PLANNING, ZONING, & BUILDING DEPARTMENT
PZ&B Staff Combination Memorandum: Architectural Commission and Town Council

SUBJECT: ARC-23-015 (ZON-23-021) 320 CHILEAN AVE (COMBO)

MEETING: JULY 26, 2023 ARCOM
AUGUST 09, 2023 TC

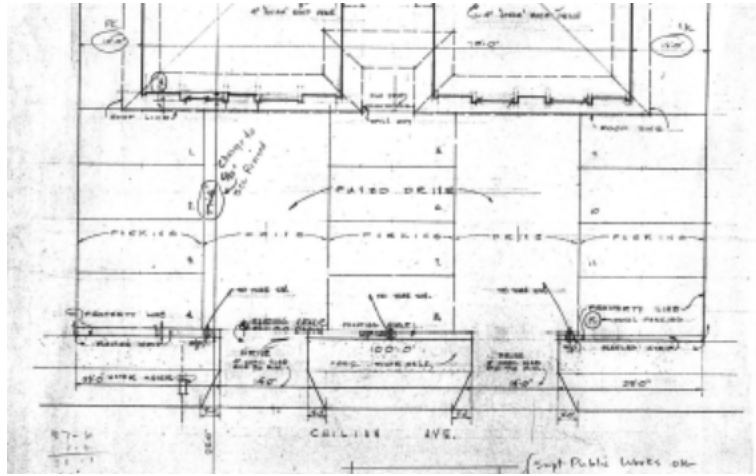
As it pertains to **Variances 1-3**, the applicant is proposing a new 8' x 20' pool in the east side yard of the building that encroaches into the required setback. As designed, the pool is located 2'-8" closer to the side property line than permitted (**Variance 1**). Additionally, the applicant has placed all the mechanical equipment within the south side yard of the building. This location exceeds the 25' maximum distance separation for pool equipment when the equipment is located within a building setback (**Variance 2**)—as proposed, the configuration is nearly 60' from the water's edge. See variance graphic below.

In addition to the pool pump and filtration system, there is also a proposed pool heater, which has a more restrictive side setback of 10'-0", rather than 5'-0" setback required other pool equipments (**Variance 3**). Staff maintains that the applicant should continue to explore ways to eliminate all of the variance requests for the installation of an amenity feature, as the reduced setback may negatively impact the neighboring duplex property.

1964 Paving Configuration

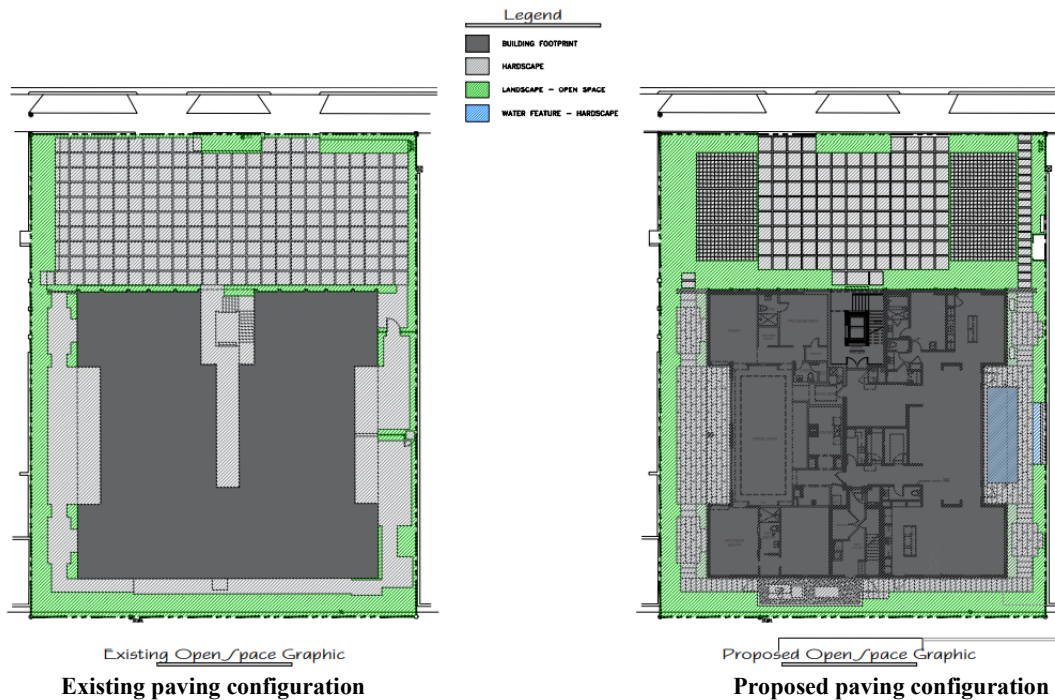
As it pertains to **Variances 4-5**, the applicant is proposing a redesign of the front yard and motor court area. The entire front area is configured as a large, paved car park area. The original 1964

design had an even greater area dedicated to car parking. See graphic below.

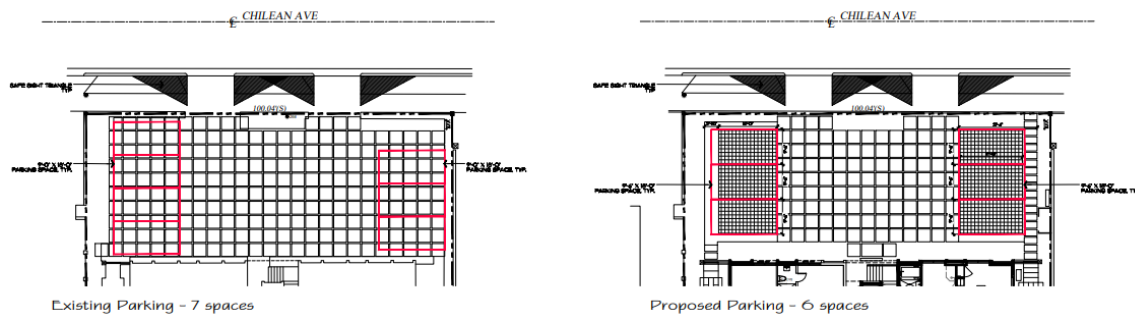
The application proposes to reconfigure the parking area and reduce the overall paving. The redesigned parkway area will be consolidated and reduced in area, resulting in an increase of the overall Landscape Open Space by 2.8%, or 364 SF.

Additionally, the redesign improves the amount of Front Yard Landscape Open Space by 2.5%, or 341 SF. Although the reduction of hardscape is an improvement to existing conditions, due to the extent of the improvements, the non-conforming Landscape Open Space (**Variance 4**) and Front Yard Landscape Open Space (**Variance 5**) must be reestablished. However, it must be noted that

the applicant seeks to install artificial turf within the joints of the paved parking area, likely for the durability of the material as opposed to designing with natural grass strips.
